# Access Compliance Report

## Public Rights-of-Way

### (Curb Ramps)

Intersection ID: 15201	Main Street: ALBEMARLE_RD	Cross Street: LAWYERS_RD	Location: NW
ADA ID: 4F4D5D04B446	Ramp Type: Perp	Initial Pass/Fail: Fail	Overall Compliance: No
		Severity Score: 10

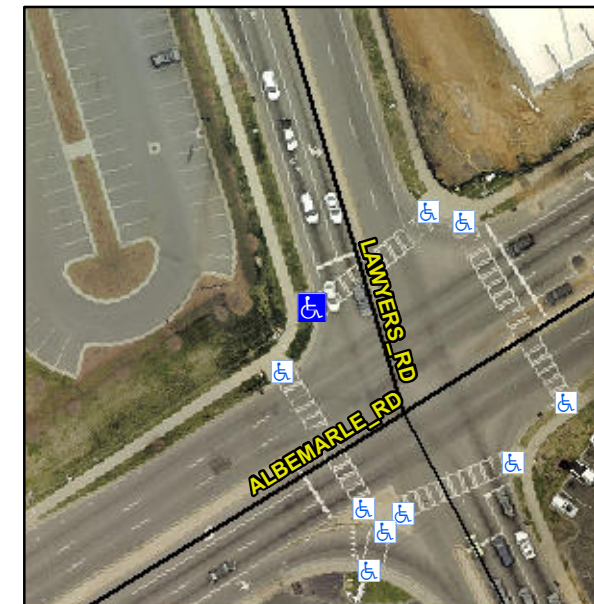
**Not Found, R304.5.1**

Compliance	Description	Data	Compliance	Description	Data
N/A	Ramp Length (in)	96.0	Yes	Ramp Slope (%)	7.0
No	Ramp Width (in)	45.5	Yes	Ramp XSlope (%)	2.9
N/A	Flare Type LT	N/A	N/A	Flare Type RT	N/A
N/A	Flare Slope LT (%)	N/A	N/A	Flare Slope RT (%)	N/A
N/A	Flare Traversable LT?	N/A	N/A	Flare Traversable RT?	N/A
N/A	Landing Length (in)	N/A	N/A	DWS Provided?	N/A
N/A	Landing Width (in)	N/A	N/A	DWS Contrast?	N/A
N/A	Landing Slope (%)	N/A	N/A	DWS Length (in)	N/A
N/A	Landing X Slope (%)	N/A	N/A	DWS Full Width?	N/A
N/A	Landing Curb? (Y/N)	N/A	N/A	DWS Offset (in)	N/A
N/A	Shared Landing?	N/A			
N/A	Gutter Ponding?	N/A	N/A	Gutter Slope (%)	N/A
N/A	Gutter Lip Ht (in)	N/A	N/A	Gutter X Slope (%)	N/A
N/A	Painted X Walk1?	Yes	N/A	Painted X Walk2?	N/A
	X Walk 1 Direction	To NE		X Walk 2 Direction	N/A
N/A	X Walk 1 Width (in)	119.0	N/A	X Walk 2 Width (in)	N/A
	X Walk 1 Slope (%)	0.5		X Walk 2 Slope (%)	N/A
	X Walk 1 X Slope (%)	3.1		X Walk 2 X Slope (%)	N/A

**Remove & Replace Entire Ramp.**
